SERVICE BULLETIN NO: 28-008

ATA CHAPTER: 28

FUEL - DISTRIBUTION ENGINE DRIVEN PUMP - TORQUE CHECK OF RELIEF-VALVE-BODY SCREWS

Torque Check and Fuel Leak Inspection of the EDP
Figure 1

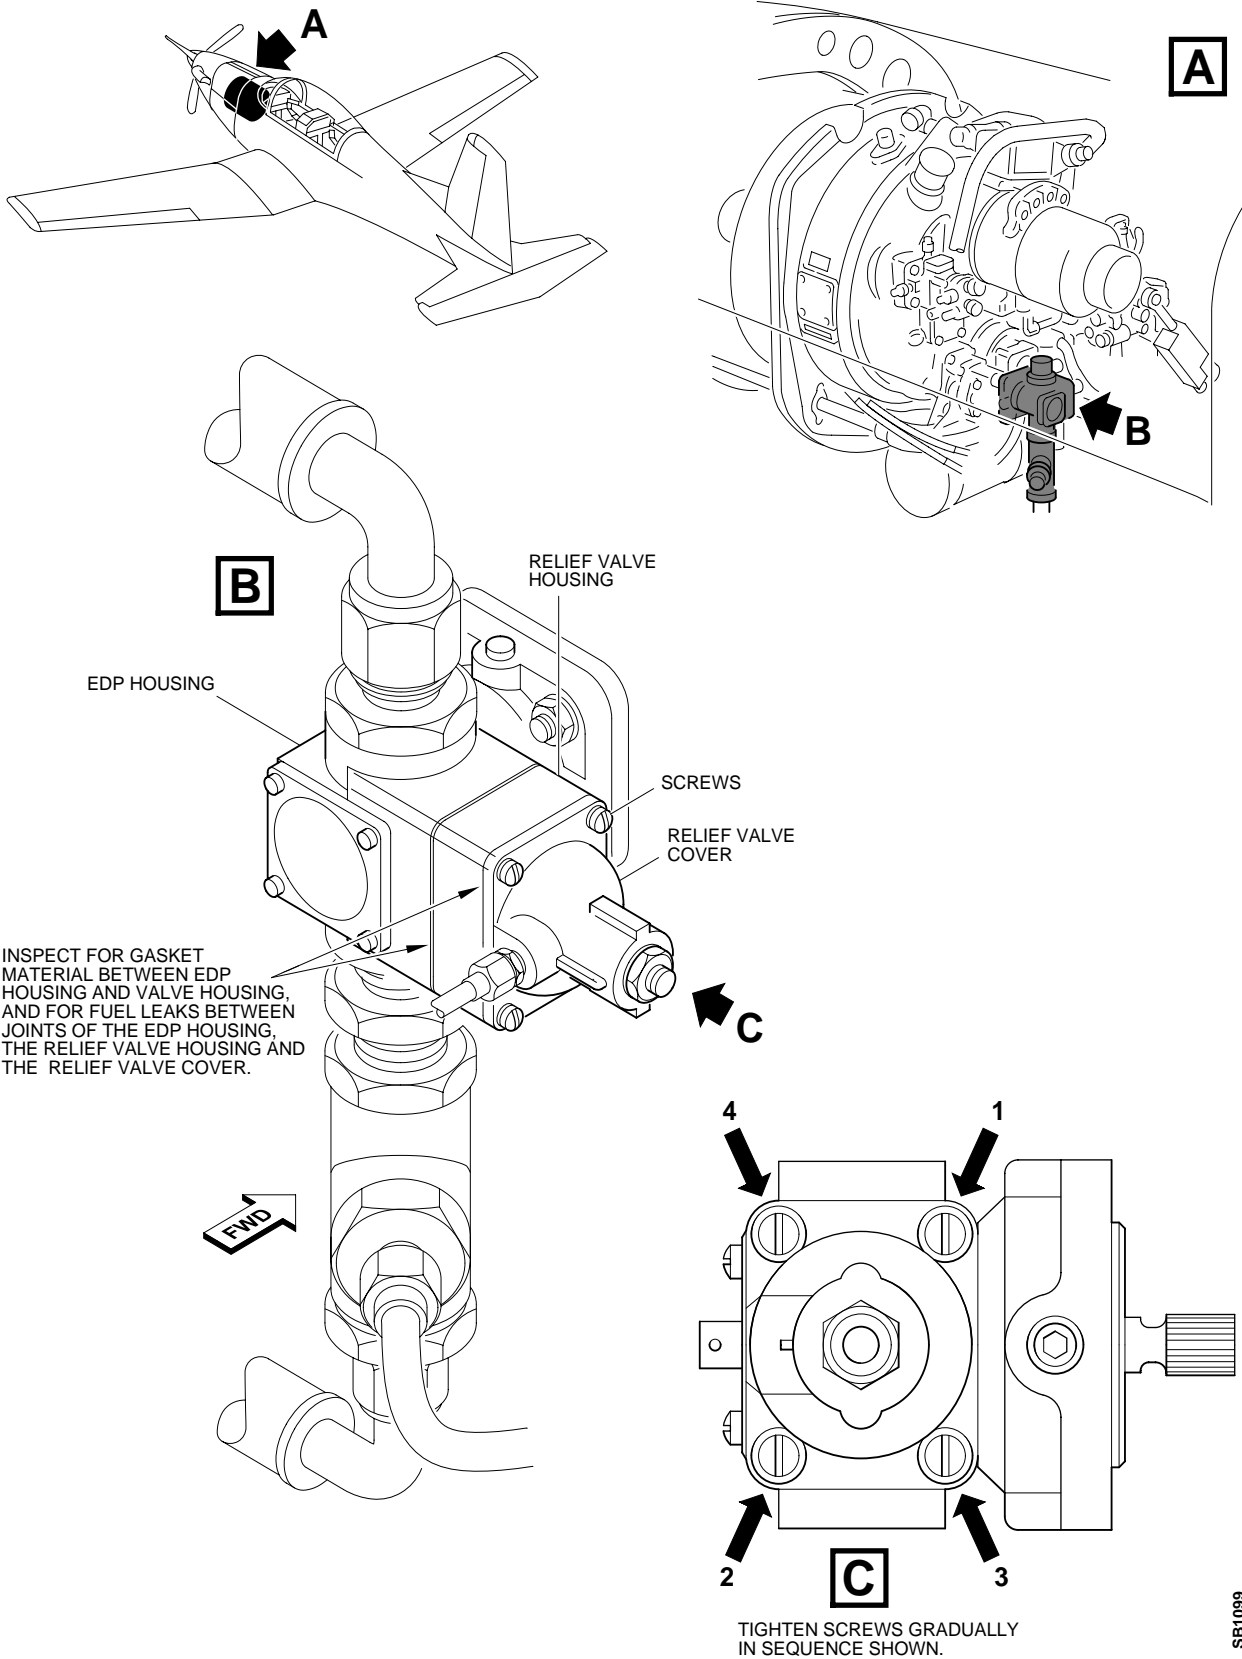
B. Inspection and Torque Check of the EDP Relief Valve (Ref. Fig. 1)

- (1) Visually inspect the joints between the EDP housing, relief valve housing and the relief valve cover for:

- Fuel leakage
- Gasket material pushed out

- (2) If the EDP shows signs of fuel leakage or the gasket between the EDP housing and the relief valve housing has been pushed out, replace the EDP (Ref. AMM, 28-20-09, Page Block 401).

- (3) Use a torque screwdriver to do a check of the torque value of the relief-valve-cover screws. Do the check clockwise only. The minimum torque must be 23 lbf in. (2,6 Nm).

- (5) If the relief-valve-cover screws are loose, or the torque found at Step (3) is less than 23 lbf in. (2,6 Nm), do as follows:

- (b) Torque the screws gradually to between 23 and 25 lbf in. (2,6 and 2,83 Nm). Do this in the sequence shown in Figure 1, Detail B.

TIGHTEN SCREWS GRADUALLY
 IN SEQUENCE SHOWN.
